- THIS SERVICE BULLETIN IS APPROVED FOR ENGINEERING DESIGN -

SUBJECT: Mooney M20J and M20K 28 volt aircraft, addition of second ground wire to voltage regula tor(s). Revision A is to correct a transposition of wire numbers in the steps below.

AFFECTED: M20J S/N 24-3000 thru 24-3129 and M20K S/N 25-1000 thru 25-1216

FIGURE SBM20-247-1

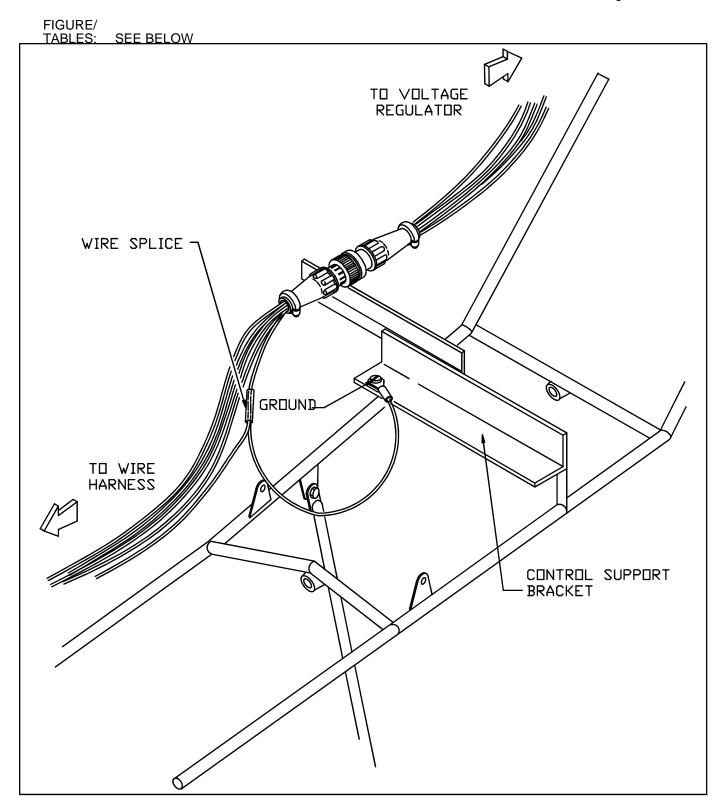
A broken alternator field ground wire may cause improper control of alternator output by the voltage regulator. To prevent this it is recommended that an additional ground be added to the wire harness close to the voltage regulator(s).

- 4. Cut wire number JK-PA14A18 approximately 4 inches from connector and strip ends. Splice back together with wire number JK-PA14B18 added to splice (routed away from connector) as shown in Figure SB M20-247-1. Repeat this procedure on second regulator with wire numbers JK-PA32A18 and JK-PA32B18 on M20K aircraft with dual alternators.

- 5. Clean paint from around hole in end of control cable support bracket and connect ground wire(s) to bracket using AN3-4A bolt, AN960-10 washers (2) and MS21045-L3, self locking nut.
